Amendments to the Drawings:

Replacement Sheet
Hiroyuki FUMIOKA
10/070,916
SOCKET FOR DIALYZER

Fig. 2

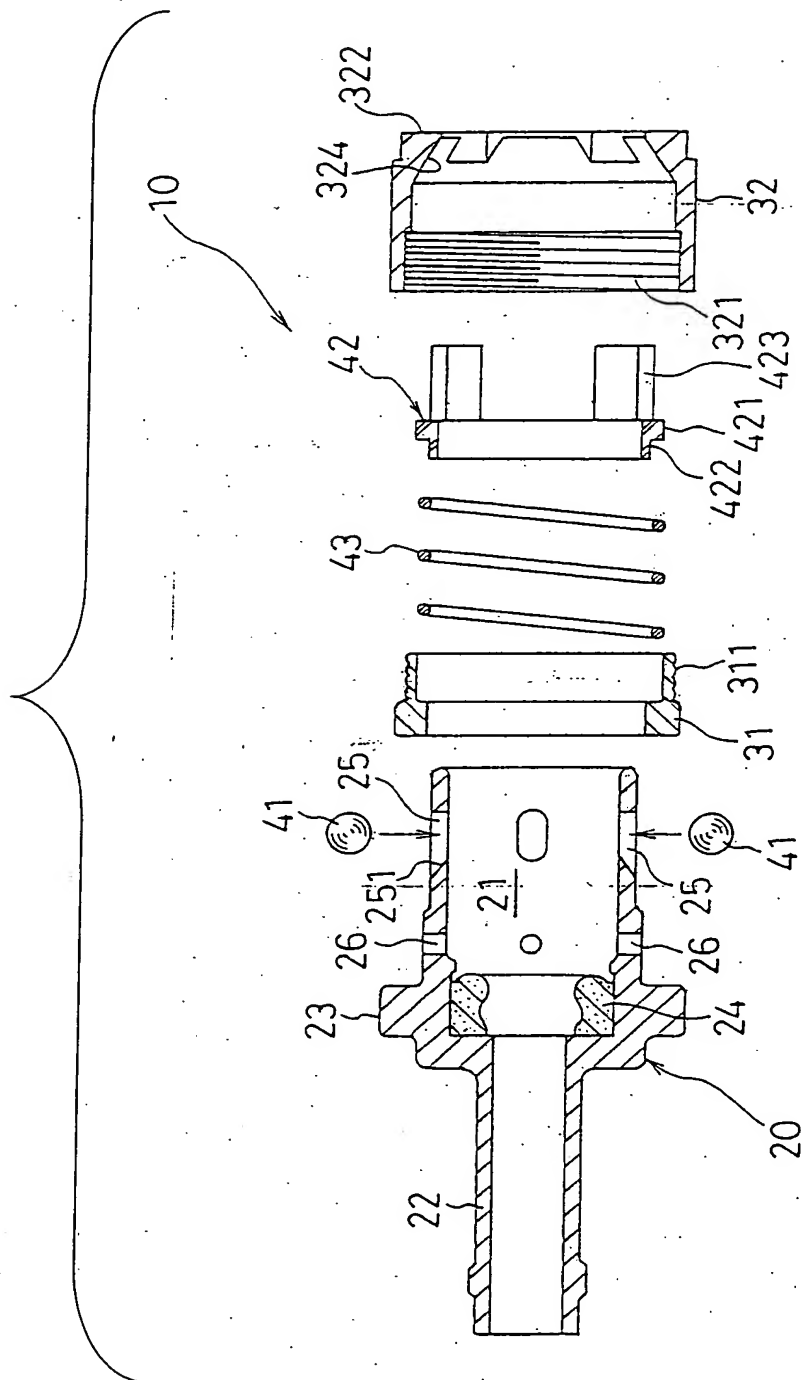
The drawing sheet attached in connection with the above-identified application containing Figure(s) 2-3 and 9-11 are being present as a new formal drawing sheet or sheets to be submitted for the previously submitted drawing sheet or sheets. The drawing Figures 2-3 and 10 have been amended to add a bracket embracing the illustrations. The drawing Figures 9-11 have been amended to add the legend Prior Art.
